CITY OF STAR

LAND USE STAFF REPORT

FILE(S) #: FP-24-08, Final Plat, Oliver Estates Subdivision

**RE: Oliver Estates Subdivision
Improvement Drawings—Submittal 1**

Final Plat

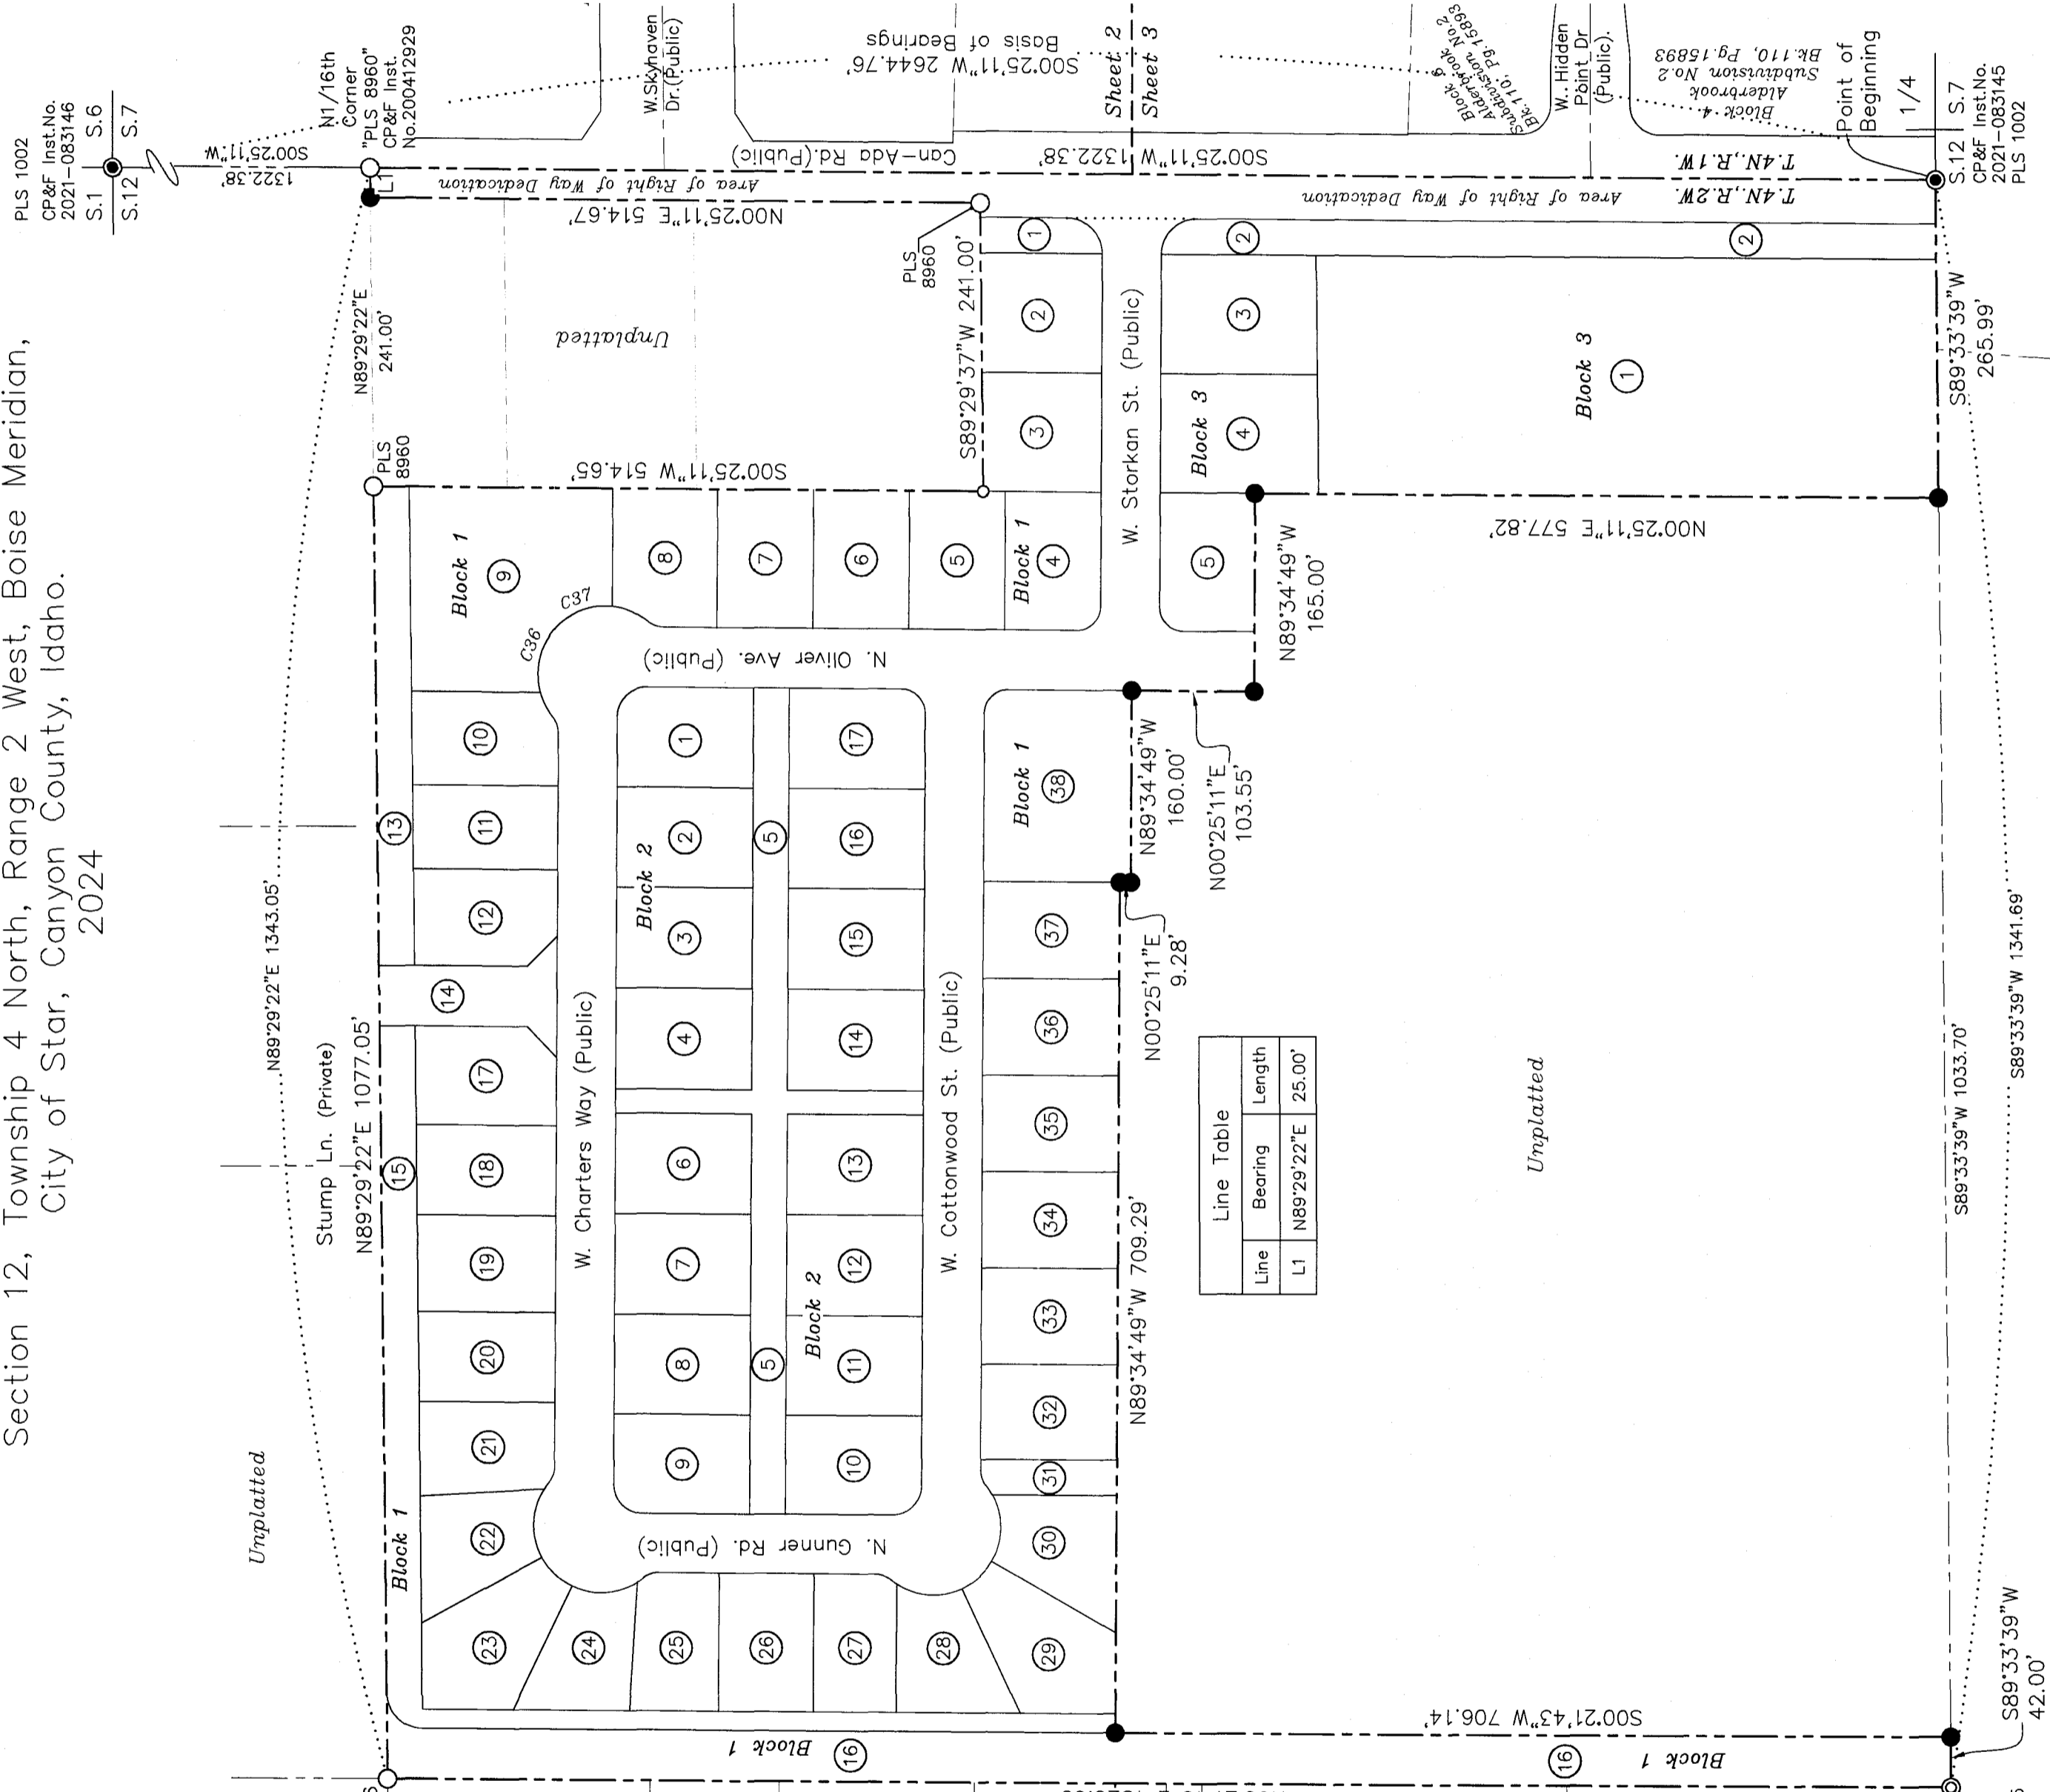
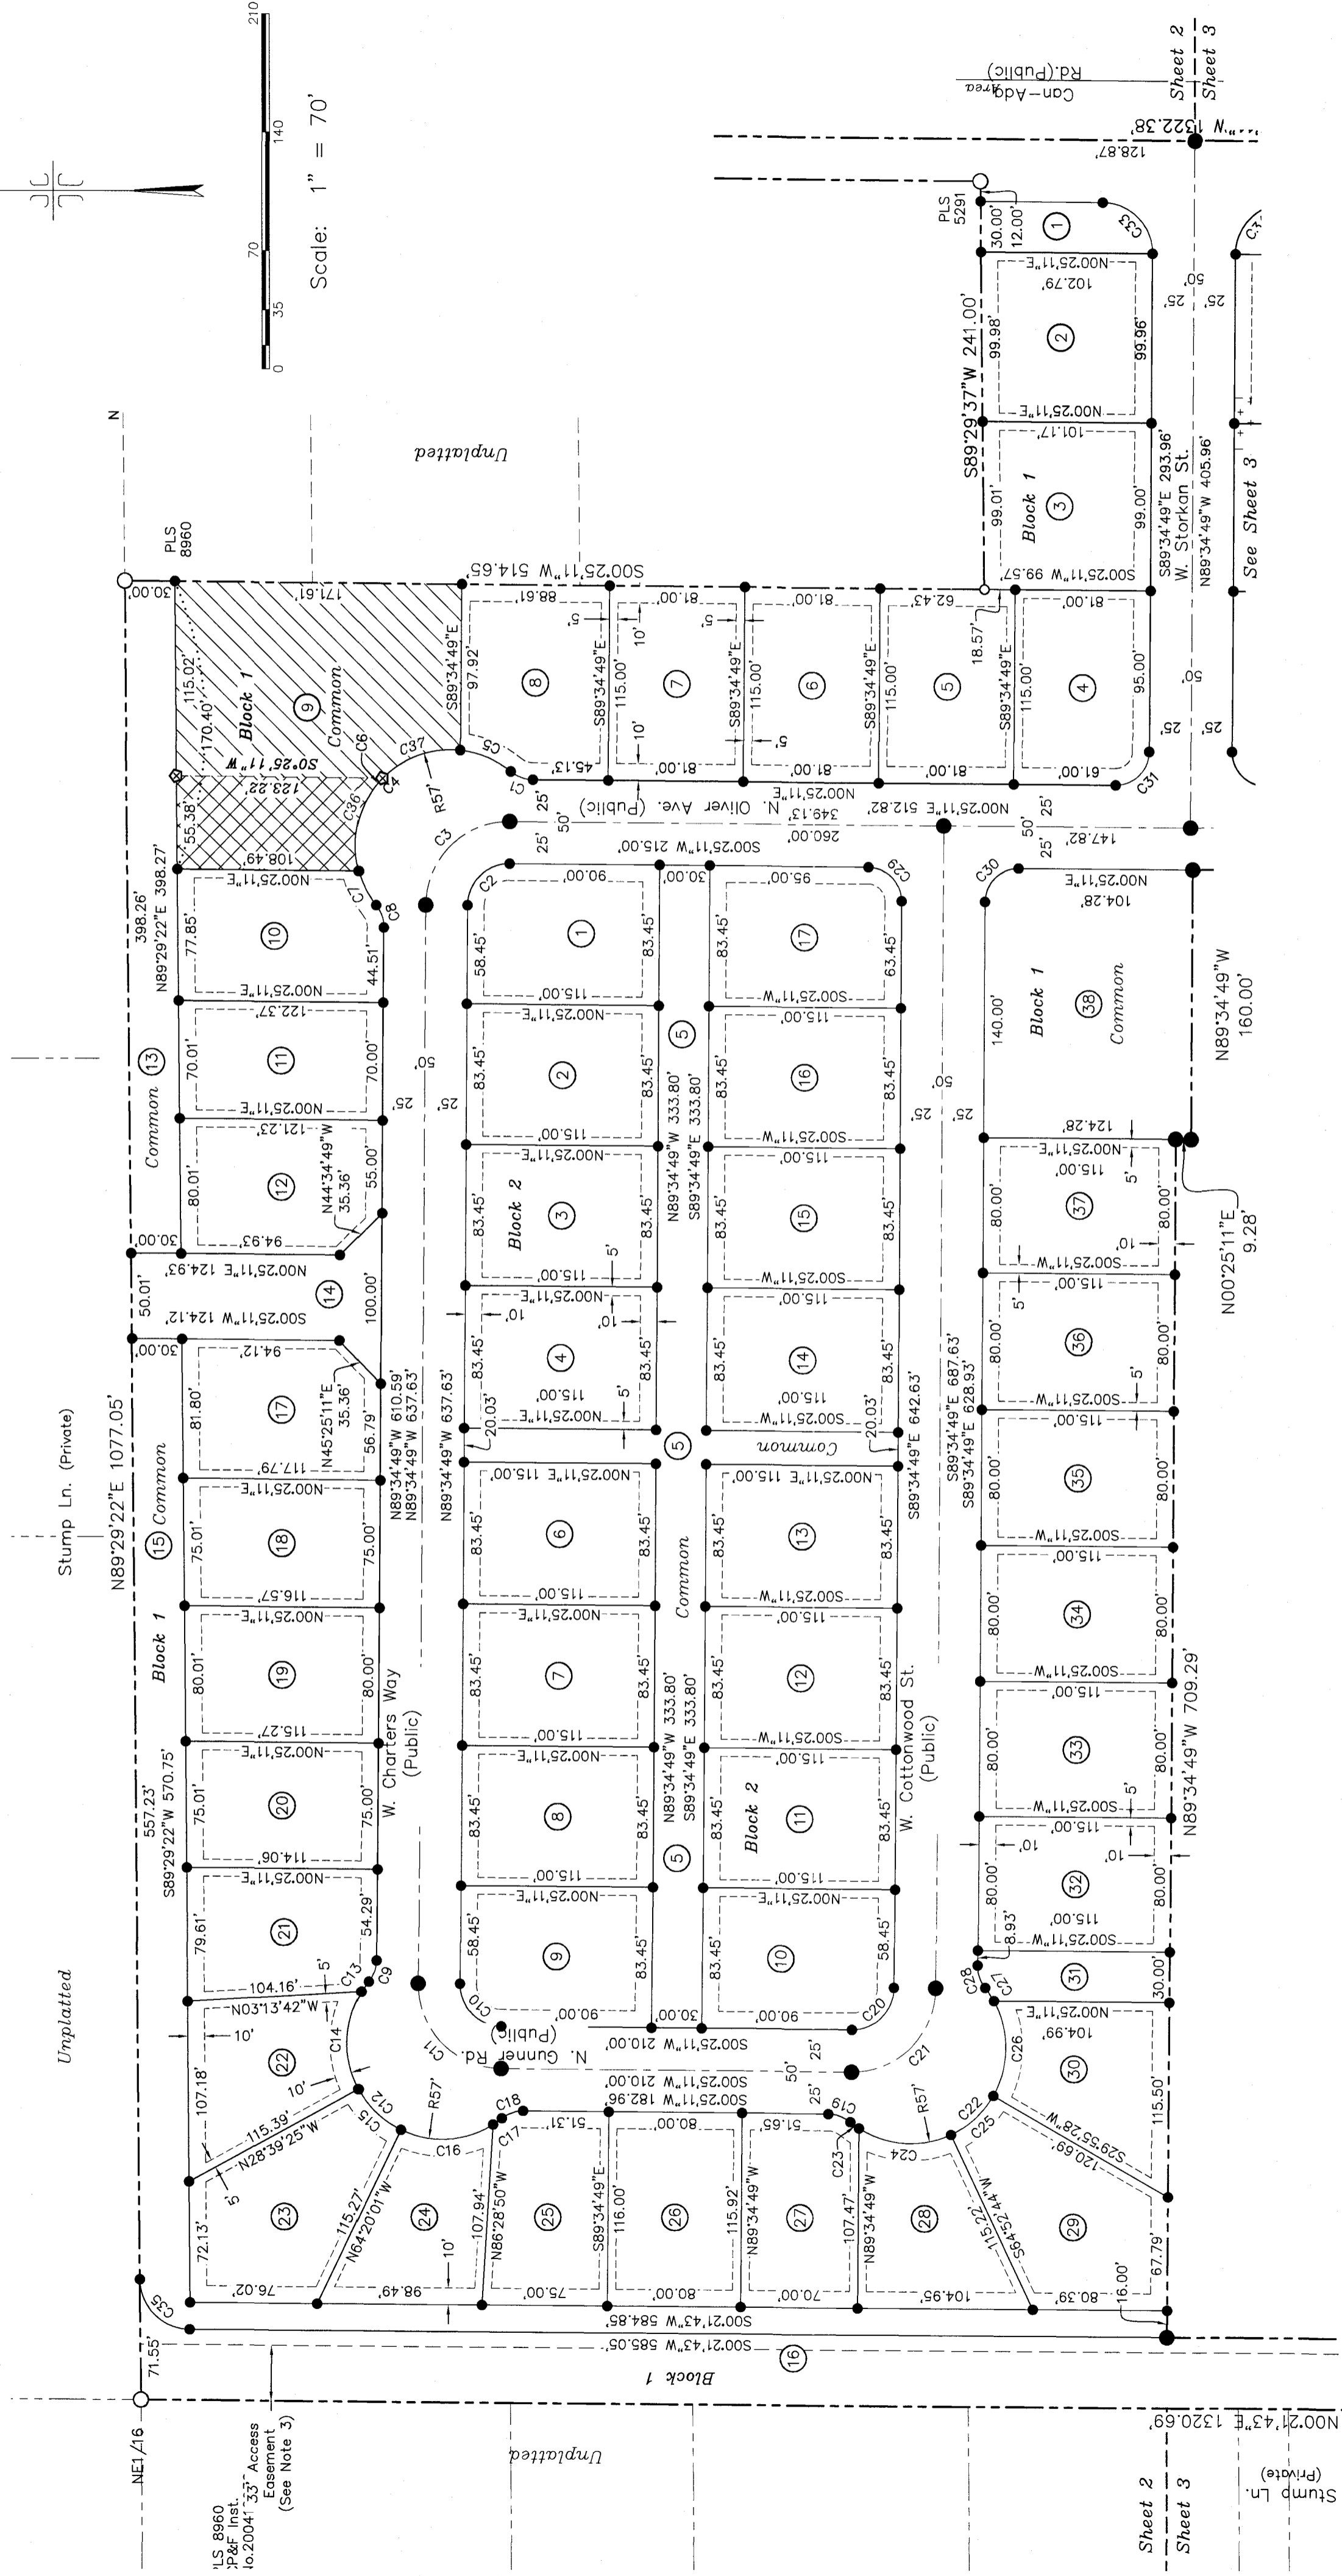
1. L1, Line table missing. Please add dimension
2. 1"=70' scale is cumbersome. Consider different scale
3. Revise Notes:
 - a. Common Lot Block 1 Lot 16= ROW
